MONTGOMERY COUNTY HISTORIC PRESERVATION COMMISSION
STAFF REPORT

| Address: | 6704 Westmoreland Avenue, Takoma Park | Meeting Date: | 4/8/2026 |
| Proposal: | Fence installation, hardscape alterations, porch restoration, door replacement, screen porch and deck construction, chimney removal, and fenestration alterations | | |

Figure 4: Existing and proposed front elevation drawings.

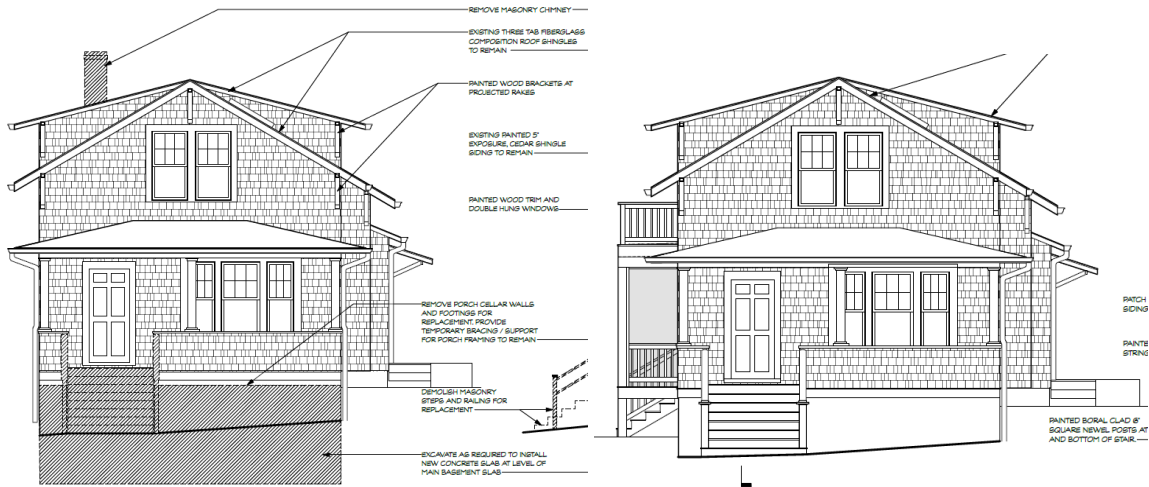
The applicant proposes numerous exterior alterations, including fence installation, hardscape alterations, porch restoration, fenestration alterations and door and window replacement, chimney removal, and construction of a screened porch and deck.

Figure 6: Site plan detail showing the proposed fence location and hardscape alterations.

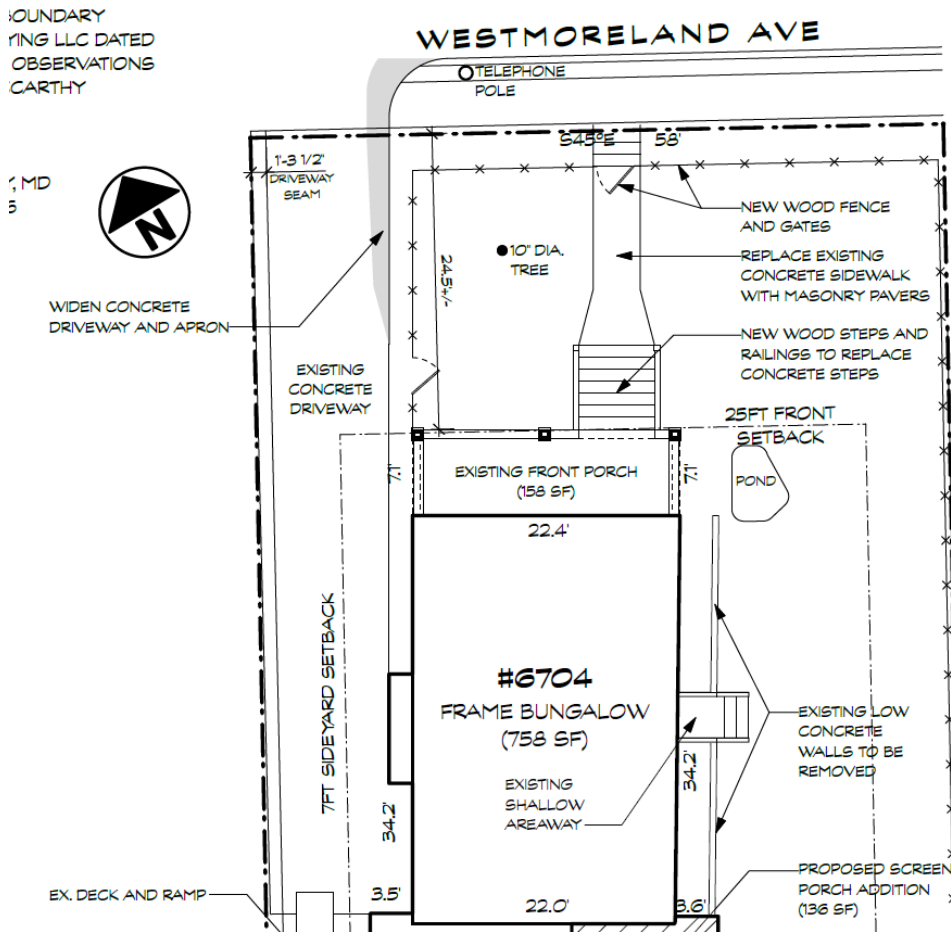
Around the front yard and in place of the existing chainlink fencing along the southeast side of the property, the applicants propose to install a new 3-½ to 4-ft tall wood picket fence. Staff finds that low, open picket wood fences are found throughout the district and consistent with the *Guidelines* and Chapter 24A-8(b)(2), and that the proposed fencing would not obscure or damage any historic features and would be removable in the future, per *Standards 2, 9, and 10.*

The applicants propose to widen the existing concrete driveway and apron approximately 12 inches, straightening the existing paving along the front yard and creating a greater turning radius for the driveway entrance. Additionally, the applicants propose to replace the existing concrete front walkway with masonry pavers and to remove existing concrete curbs around planting areas on the southeast side of the house. Staff finds that the additional minimal driveway alterations, walkway replacement, and removal of the existing concrete curbs around the planting beds on the southeast side of the house do not remove a character-defining feature of the property and will not have a substantial impact on the exterior features of the resource, per *Standard 2* and Chapter 24A-8(b)(1), and that the proposed pavers are compatible with the resource, per Chapter 24A-8(b)(2).

1. Front yard fencing must be below 4-ft in height.
2. The applicant must submit installation details and simulated-divided-light muntin dimensions and profiles for the windows proposed for replacement on the main block.

Figure 10: Wall section showing the proposed porch alterations.

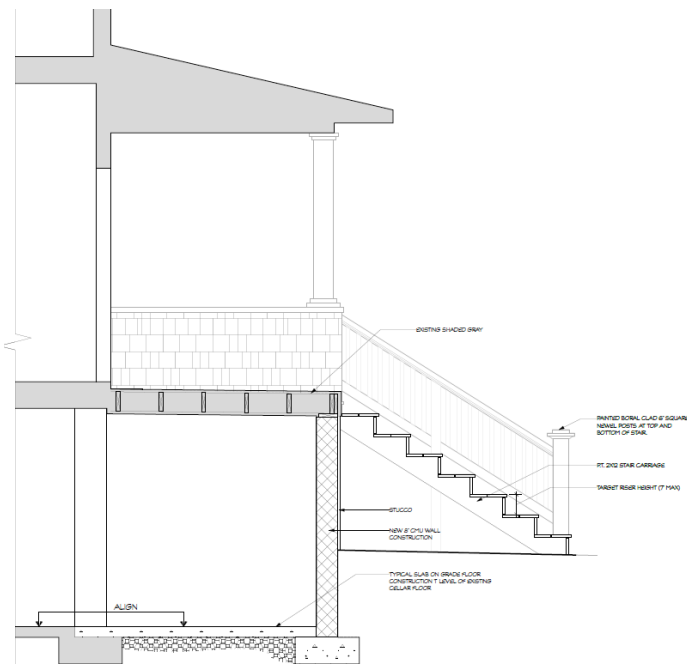
The applicants propose to make several changes to the existing front porch, including rebuilding the cracked foundation and replacing the existing shake skirting with stucco over CMU, removing the existing concrete steps, and installing new Boral-clad pressure treated wood steps with painted Boral risers and newel posts, Aeratis plank treads, and wood railings. New Weathershield windows would be installed on the side elevations of the porch to match the size and appearance of the existing windows. Staff finds that the proposed alterations are consistent with the style and period of the house, per the *Guidelines*, and that the design and materials are compatible with the resource per Chapter 24A-8(b)(2) and *Standard 9*. Staff finds that the proposed Aeratis plank treads are a compatible substitute material, in keeping with *Policy 24-01*.

Figure 11: Existing and proposed northwest side elevation drawings.

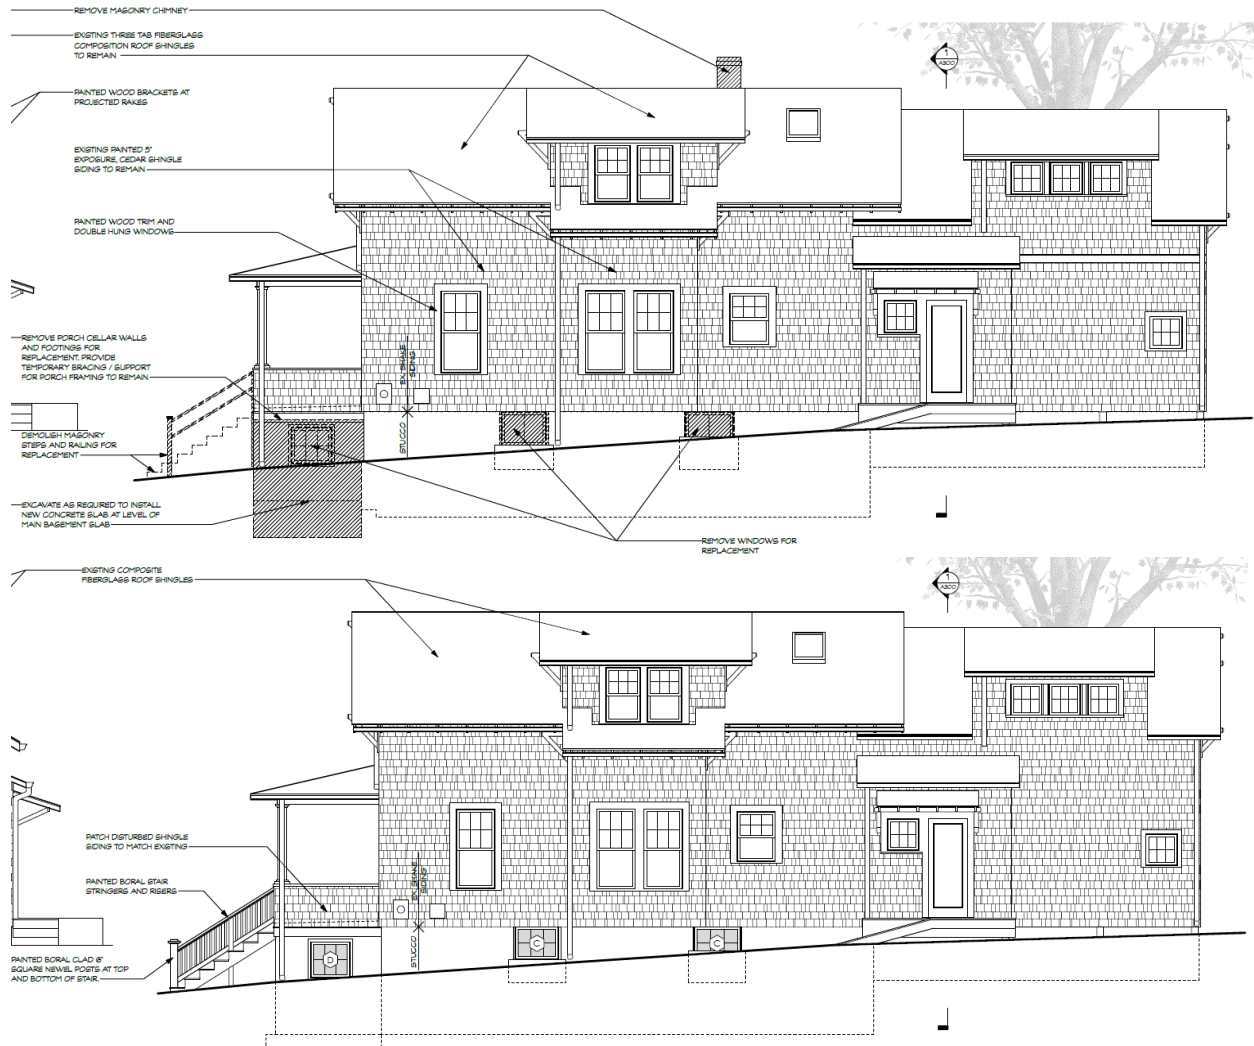
In addition to the windows proposed for replacement on the front porch, the applicants propose to replace existing basement windows on both side elevations. On the northwest side elevation, two-light sliders would be replaced with six-light Weathershield awning windows. On the southeast side elevation, two six-over-one double-hung windows would be replaced with new six-over-one casement windows with a simulated meeting rail. Staff notes that a change from double-hung to casement windows will remove the offset plane between the sash, but finds that the overall design is consistent with the *Guidelines* and owing to their location at the basement level and on a secondary elevation, will not substantially alter the exterior features of on the resource, per Chapter 24A-8(b)(1). Staff notes that the application currently lacks details on the materials, profiles, and installation method of the proposed windows, and recommends that the HPC condition the application upon submission of these details and the use of simulated-divided-lights.

Figure 12: Existing and proposed southeast side elevation drawings.

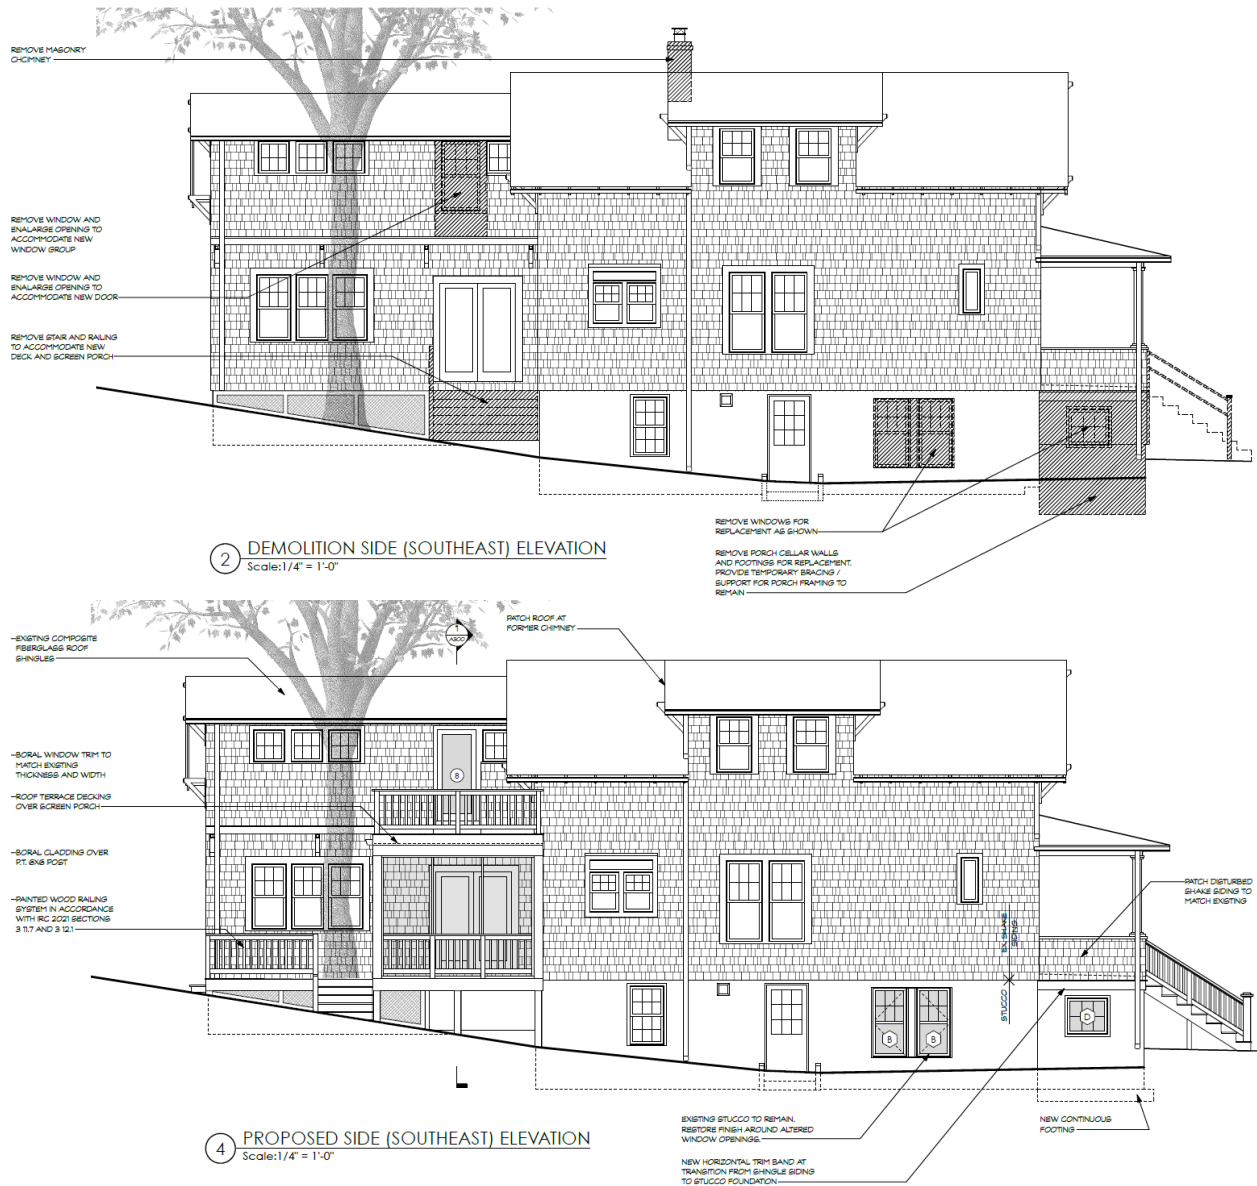
Off the rear of the main block and along the southeast side elevation of the rear addition constructed with HPC approval in 1993, the applicants propose to construct a new deck and screened porch with a roof terrace above.¹ The proposed screened porch would extend approximately 3-½ feet beyond the side wall

plane. The lower-level deck be narrower and would be constructed around a 32-inch d.b.h. tree, which is not proposed for removal. At the first floor rear of the main block, the applicants propose to enlarge an existing window and install three new windows. On the southeast side elevation of the existing addition, the applicants propose to enlarge an existing window opening to create a new door. Although the proposed porch extends beyond the side wall plane of the main block, staff finds that the open nature and scale of the proposed porch is compatible with the historic structure and presents as subordinate to the historic building, per *Standard 9* and Chapter 24A-8(b)(2). Staff further finds that the proposed construction does not require the removal of or damage to distinctive materials or features that characterize the property, in keeping with *Standards 2* and *9*, and that the changes to the rear wall of the main block are not visible from the public right-of-way and should be approved per the *Guidelines*.
